**RE: Cascade Natural Gas Corporation's Response Comments regarding LC 69 2018 Integrated Resource Plan**

2018 Integrated Resource Plan (LC 69)

Cascade Natural Gas Response  
Comments

Request No. 26

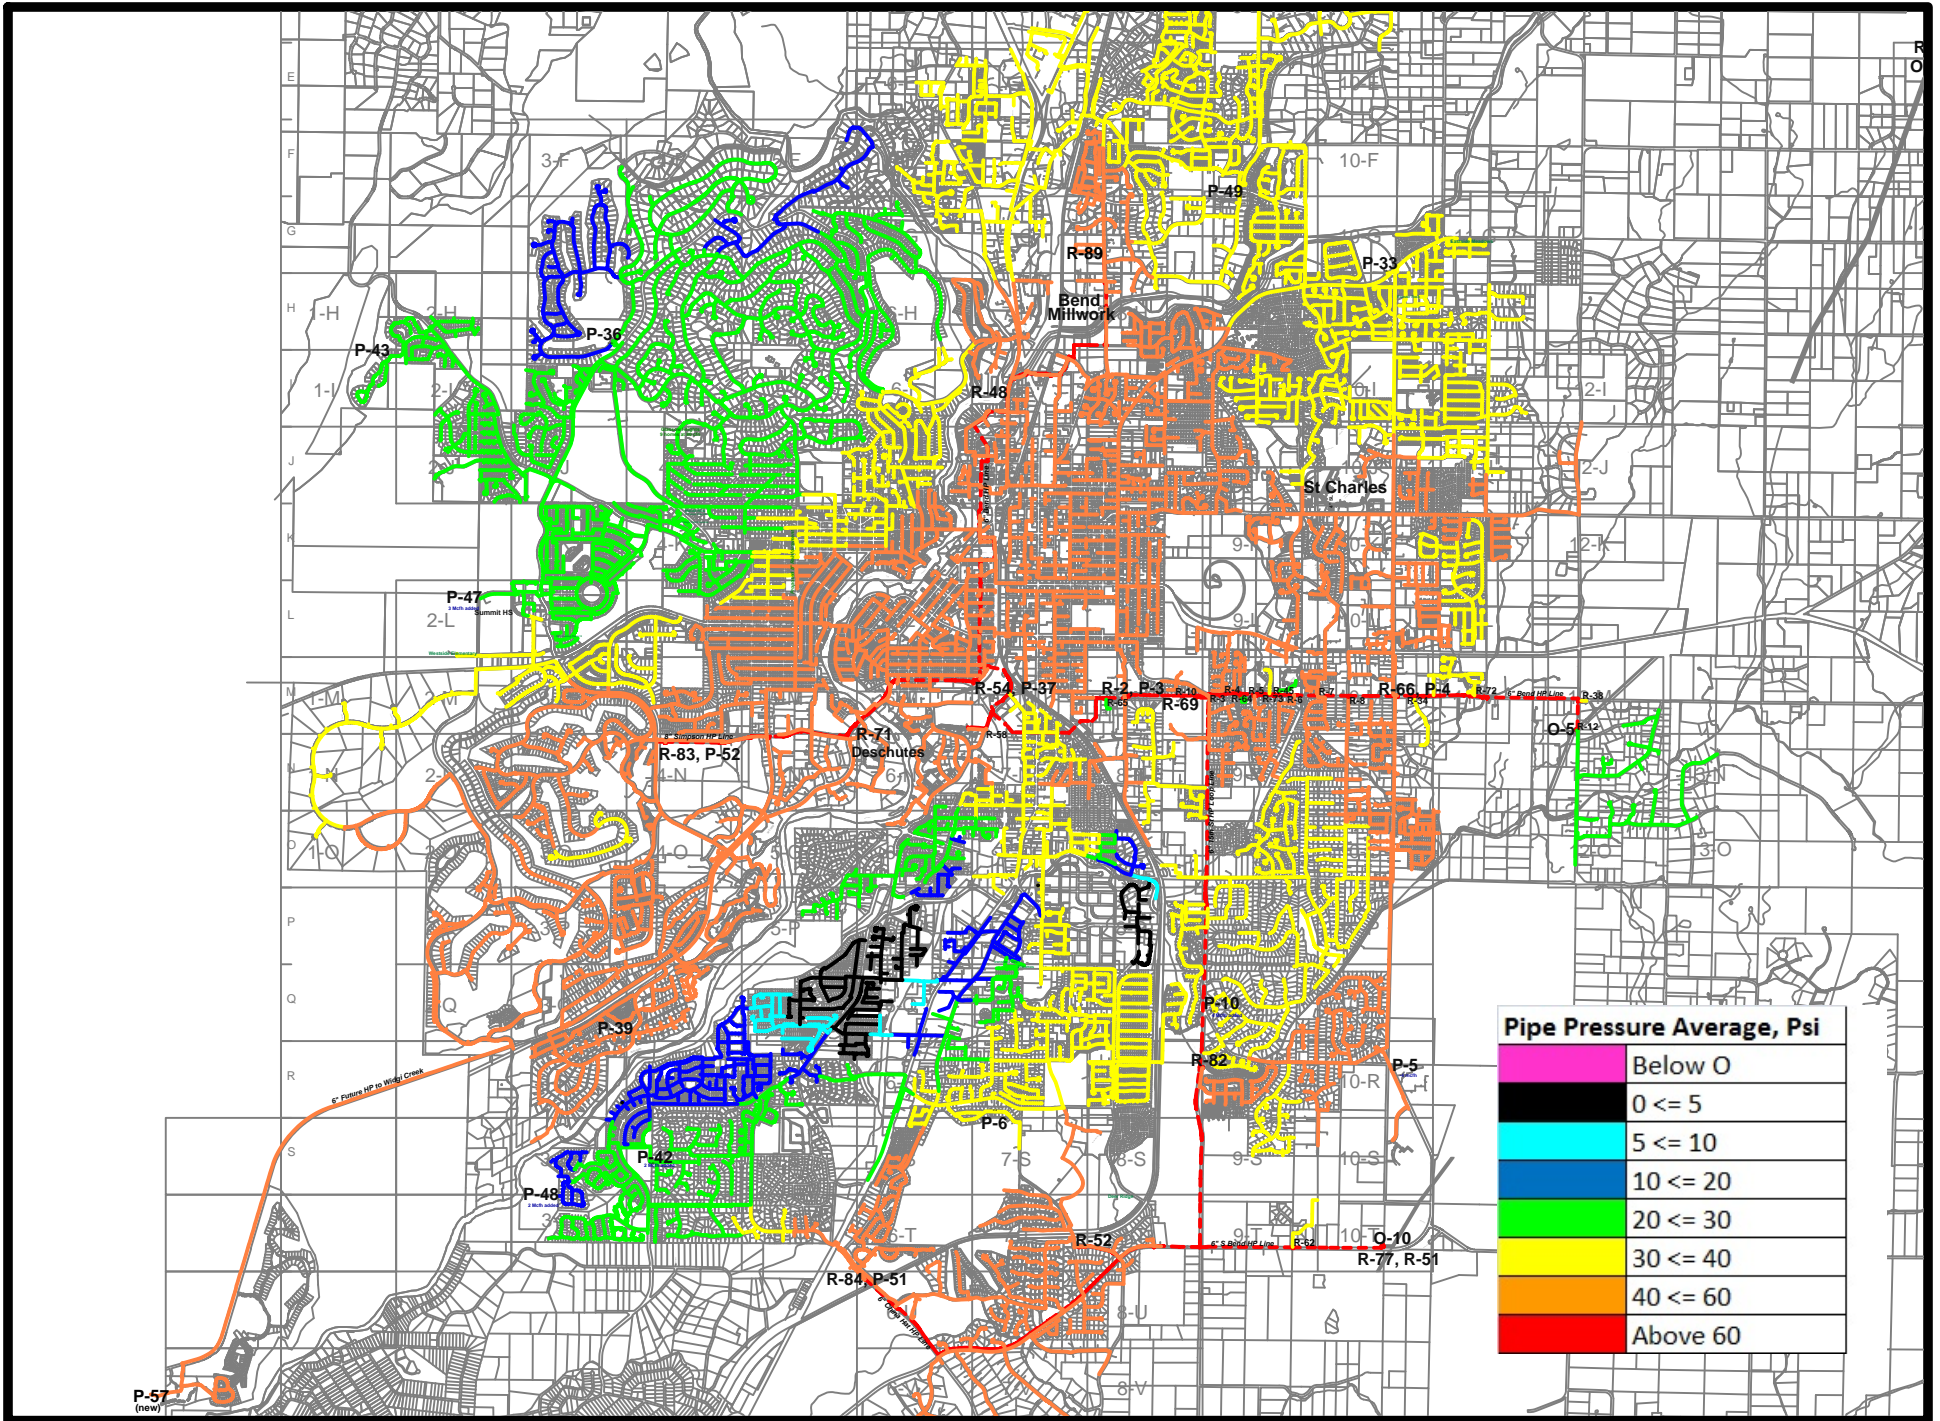
26. Page 3-16: CNG asserts 1.3% growth in poor economic conditions
- a. Please provide data showing load data in any of the Oregon Zone during the two most recent economic downturns that corroborate such an assertion for past downturns.

As discussed on page 3-8 of the 2018 OR IRP, Cascade derived its high and low growth load projections by using the confidence intervals of its ARIMA models. This allows for a low growth scenario that, statistically speaking, captures an extreme low growth environment as it is one that only occurs 2.5% of the time. This model was discussed during Cascade's first TAG meeting for the 2018 OR IRP with no objections.

Additionally, the forecast of 1.3% growth in poor economic conditions assumes that, similar to recent economic downturns, conditions will eventually improve. The attachment DR 25, 26 - Historic Customer & Therm.xlsx provides an example of this. Even when including poor economic conditions in 2008-2009 (0.59%) and 2011-2012 (0.79%), growth over the entire ten-year horizon was approximately 1.6%.

# 2012 Bend Design Day Model

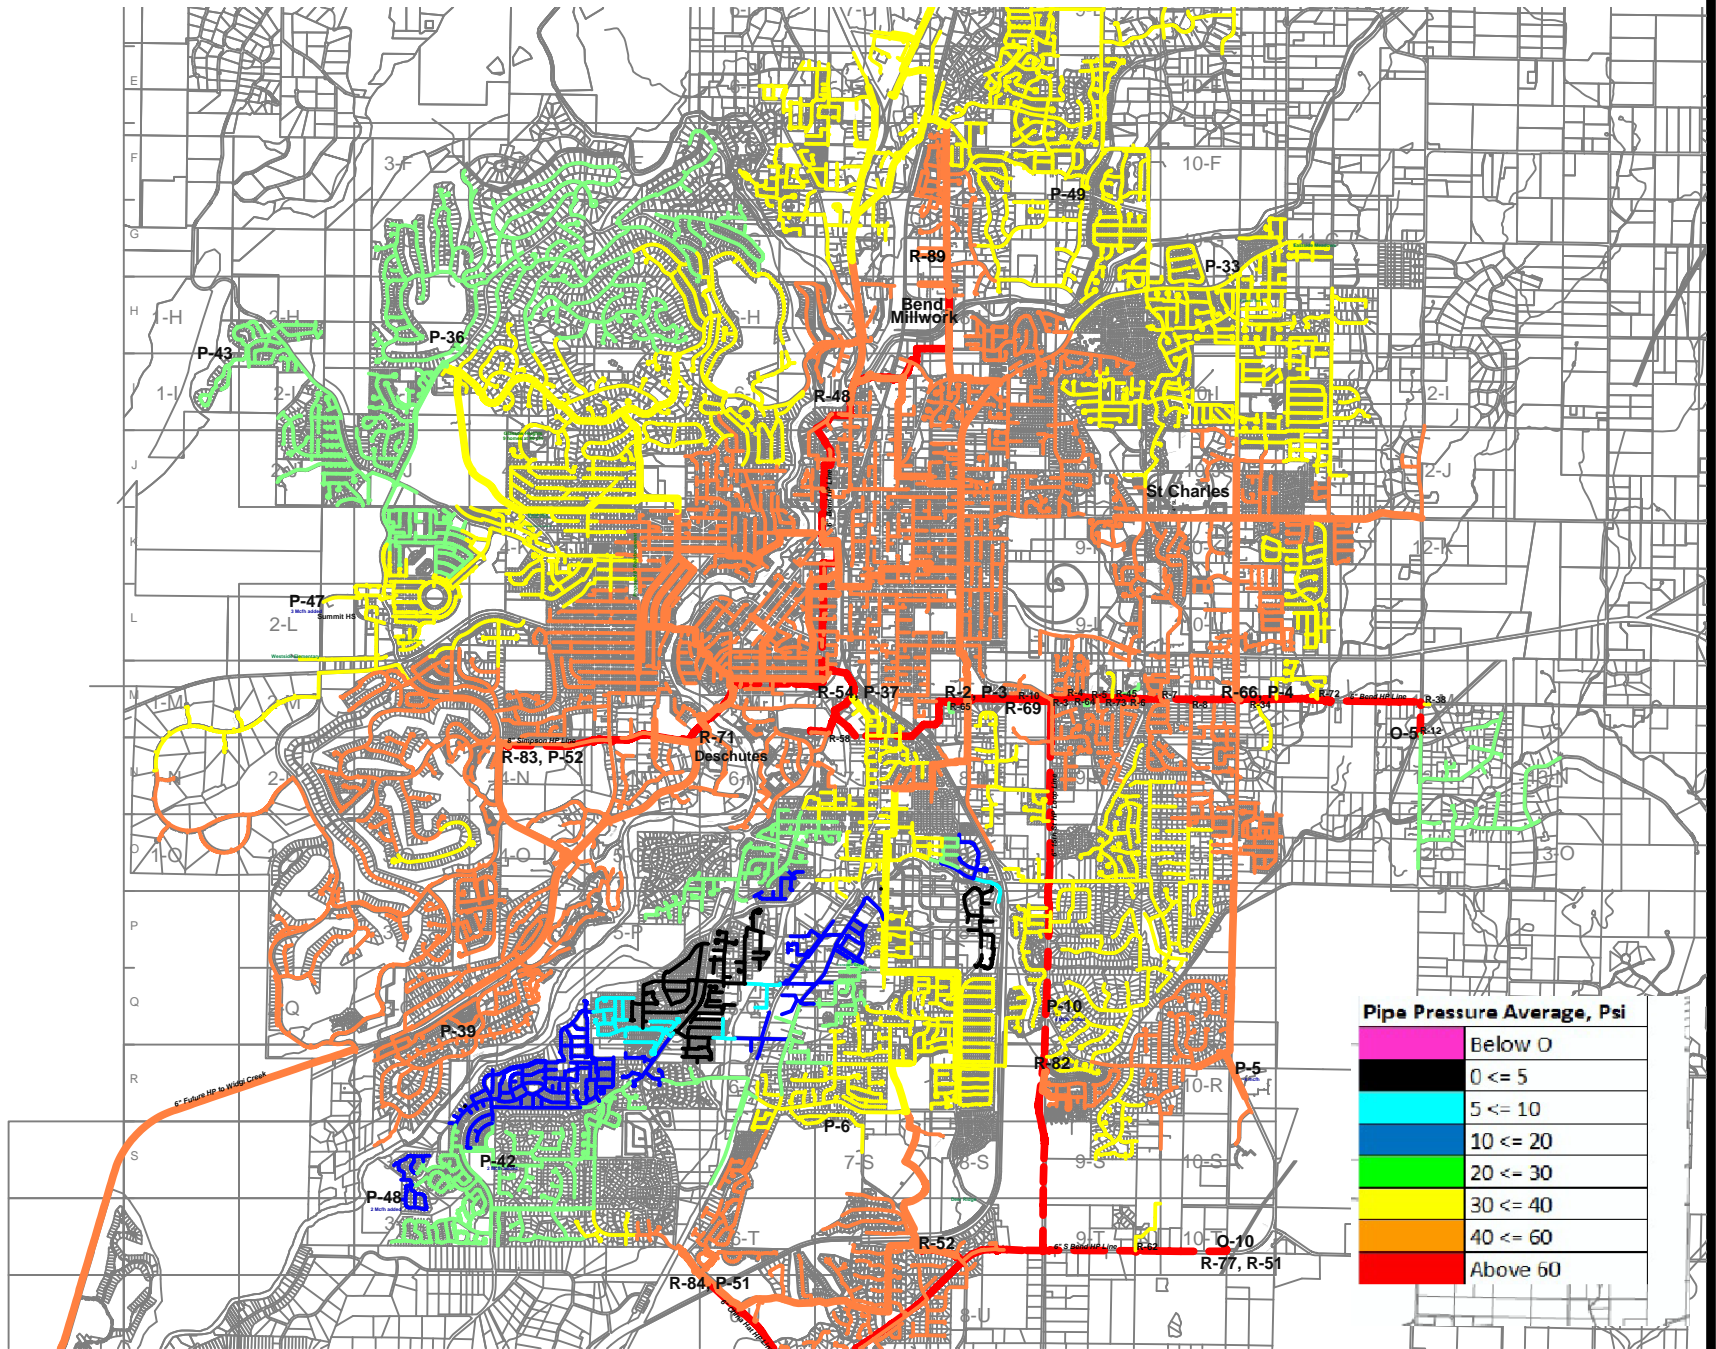
32. In CNG's most recent Safety Project Plan (UM 1899) the Company reported a need for investments to replace corroding pipelines in Oregon, the estimated cost of which exceeds a cumulative 15 million dollars. Could these infrastructure replacements impact the future cost of expansions and/or limit the Company's ability to expand its distribution system in the future? Has the Company considered cost mitigation strategies such as accelerated DSM? Please provide any model calculations and inputs that address these issues.

When the infrastructure replacements mentioned above are planned, flow modeling is performed to ensure that the new pipelines will have sufficient capacity for future growth in the area. Usually, these projects are in well established residential areas that have been fully built out, and any future growth would be minimal. Attachments DR 32 - 2012 Bend Design Day Pressure.PDF, DR 32 - 2012 Bend Model Design Day Pressure with Bend Replacement Sizing for all PRE-CNG pipe.PDF, and DR 32 - Pressure Comparison Pendleton Phase I.PDF show the before and after modeling outputs for two different projects, one in Pendleton and one in Bend. The Pendleton project is shown in tabular format, demonstrating the increased pressures available at the nodes after the pipe has been replaced. The Bend project is shown in a graphical format.

# PILOT ROCK 6" IP PE REINFORCEMENT

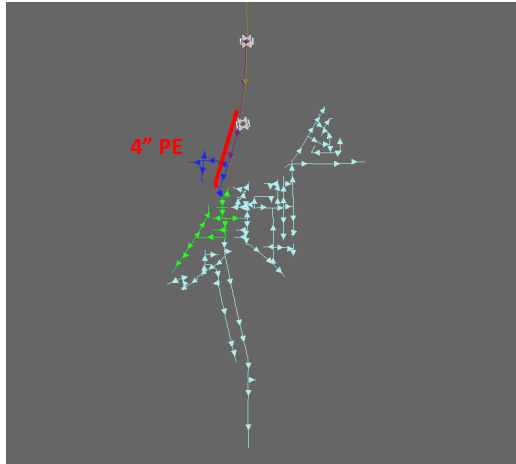
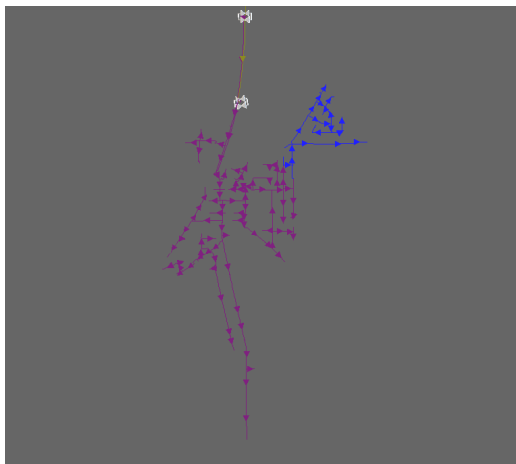
50. Please provide the Synergi model data (including current distribution system infrastructure, operating pressures, etc) and maps for the three near-term projects described in 8-10.

- 2017 PROJECT
- 1,950' OF 4" PE
- HAVE EXPERIENCED LOW PRESSURE DURING PEAK HEATING
- ALLOW FOR GROWTH IN SYSTEM

➤ DESIGN DAY PRESSURE BEFORE/AFTER
